# 802.11h™

**Amendment 5: Spectrum and Transmit Power  
Management Extensions in the 5 GHz band in  
Europe**

**IEEE Std 802.11h™-2003**  
(Amendment to IEEE Std 802.11™, 1999 Edition (Reaff 2003),  
as amended by  
IEEE Stds 802.11a™-1999, 802.11b™-1999,  
802.11b™-1999/Cor 1-2001, 802.11d™-2001,  
and 802.11g™-2003)

**Figure 27—Capability Information fixed field**

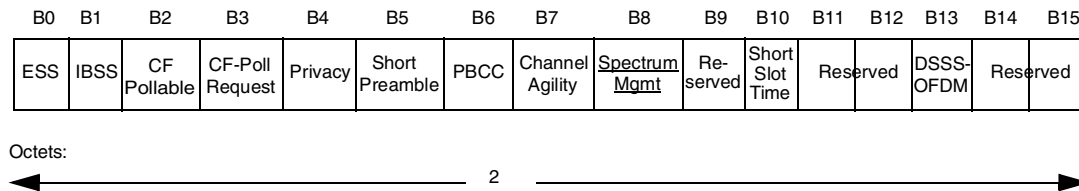
*Change the contents of Figure 27 as shown:*
